Re: Docket No. 50-275-OL  
 Docket No. 50-323-OL  
 Diablo Canyon Units 1 & 2

Enclosed in support of our operating license application are responses to informal questions 1 through 10 transmitted to PG&E in an August 4, 1978 memorandum on the subject of seismic qualifications.

This package contains non-proprietary responses to informal questions 1 through 10 transmitted to PGandE in an August 4, 1978 memorandum on the subject of Seismic Qualifications.

Fig. E-19

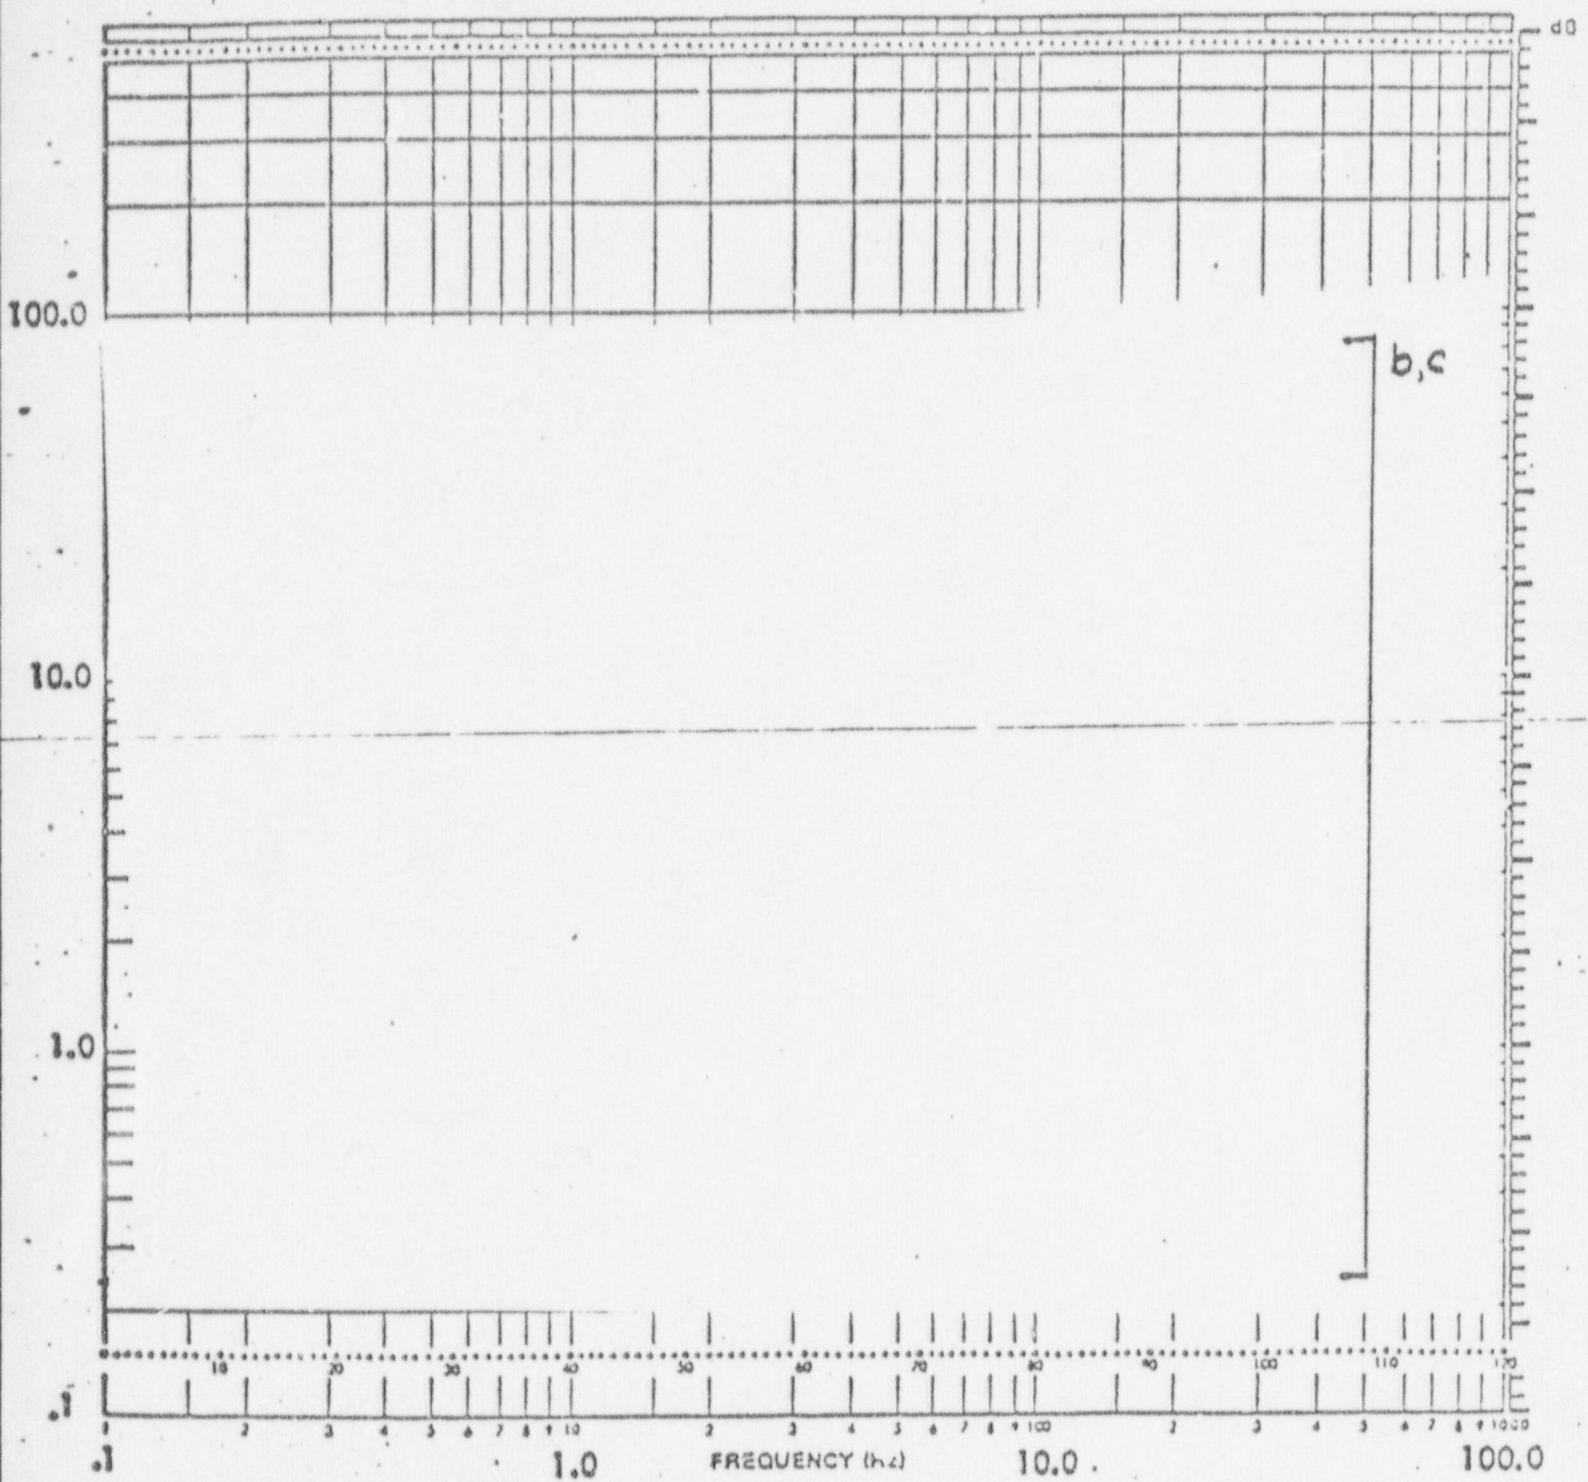
- d) The transmitter were only tested at some normal value as indicated in Section 10.3.17.2 of the FSAR Amendment 50. Define normal value and justify not testing over the full range of pressures, levels, or flows that these transmitters would be expected to operate.

The seismic tests of the pressure and differential pressure transmitters was performed using multifrequency triaxial inputs which conform to the requirements of standard IEEE-344-1975.

The multifrequency inputs were developed in accordance with the guidelines for frequency content and phasing set forth in WCAP-8624; "General method of developing multifrequency biaxial test inputs for bistables."
